LIVSEY & COMPANY, INC.
DONALD C. COOK NUCLEAR PLANT

FLOW DIAGRAM 1-5114A
O.S.L. 04
CONTAIN. VICINITY
DWG. NO.
1-NSW-63
SH. 1 OF 2

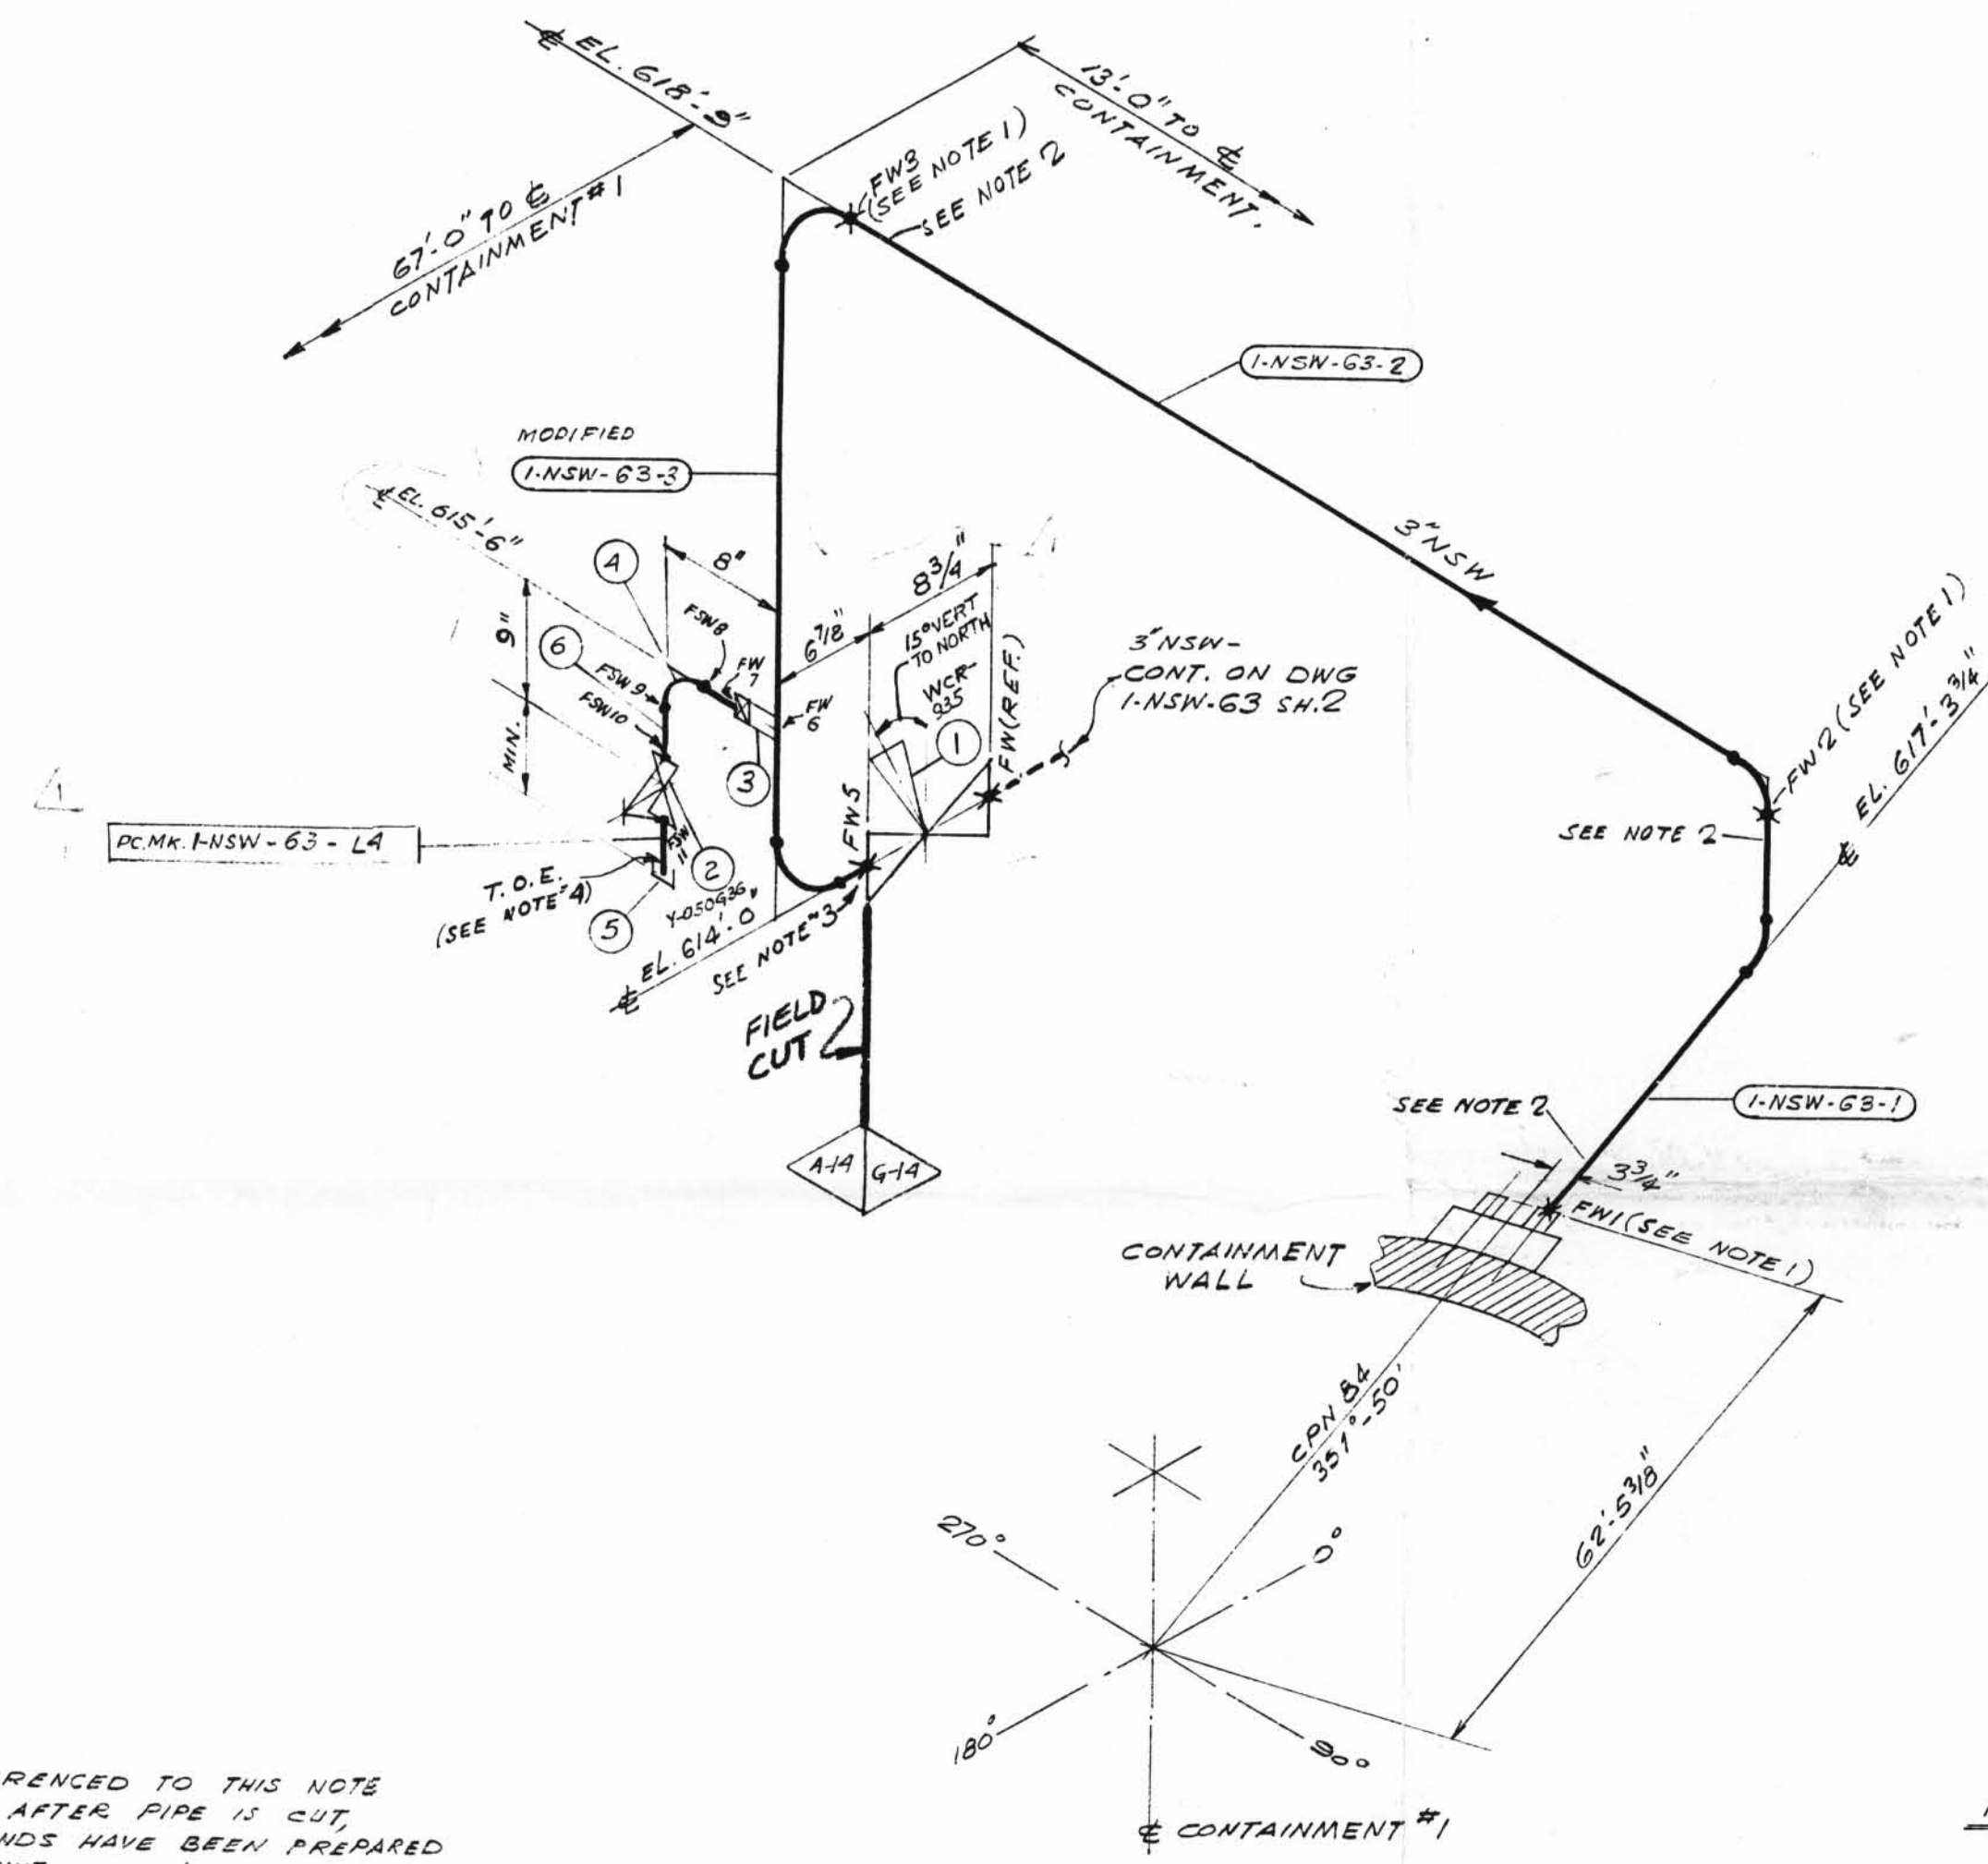
REVISION RECORD			
No	DATE	DR. CHK.	DESCRIPTION
1	1/13/82	KA E.J.G.	PER RFC-DC-12-2549 ADDED DIM'S, NOTES 3&4, PC.MK. L4, FIELD WELD BOX, FW5 TO 7, FSW 8 THRU 11, ITEM 'N'S 2 THRU 6 TO B/M. REVISED ITEM N2 B/M. MODIFIED PC.MK. 3.
